## W-BEAM TREATMENTS

### REVISION REGISTER

Refer to: HMHS-B58

Figure 8. Summary of Test Results and Sequential Photographs, Test OLS-3 (Design No. 3)

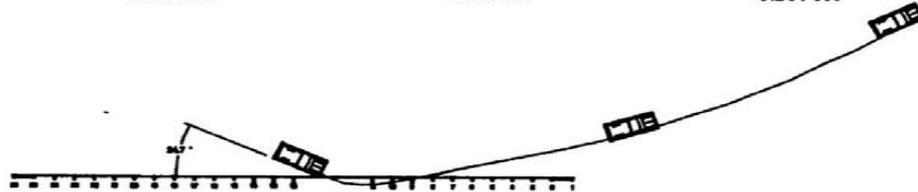
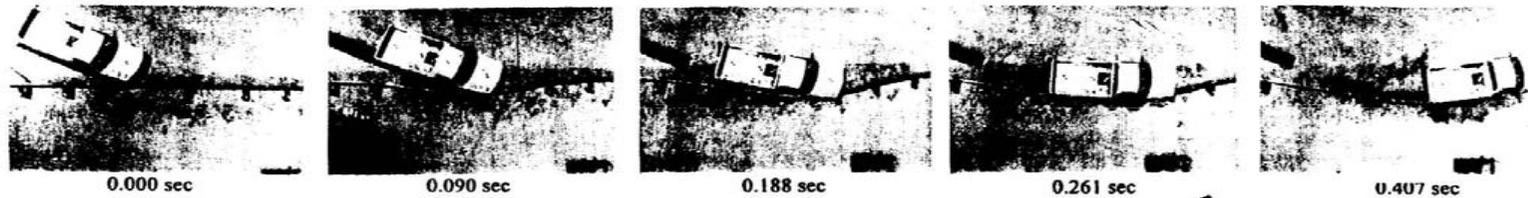
Your design was tested with a 2000-kg pickup truck impacting at 102.4 km/h and at an angle of 24.7 degrees. The impact point was 2.44 m downstream from post number 12. All Report 350 evaluation criteria were satisfactory. Summary test results for Test No. OLS-3 are shown as Enclosure 2. The reported dynamic deflection of the barrier was 1450 mm. The report also cautioned that, since the rail deflected 1450 mm in the test, a minimum distance of 1.5 m behind the rail should be clear of any fixed-object hazards that could snag an impacting vehicle.

We noted that the tested design used four nested w-beam rail elements that were 3810-mm long in the middle of the 30.48 m nested-rail section. This design layout placed a splice in the center of the clear span. Your report implied that this was an assumed "worst case" situation, and that the splices could be located anywhere within the nested section. For example, four 7620-mm long nested segments could be used in lieu of the tested two 7620-mm and four 3810-mm long segments. Finally, you stated that the long span design would perform acceptably if standard timber posts were used in lieu of steel line posts. We agree that these options would also be acceptable.

Based on our review of the information you submitted, the FHWA considers the long-span design to meet Report 350 evaluation criteria at Test Level 3 (TL-3) and it may be used where appropriate on the National Highway System when such use is recommended by the State transportation agency.
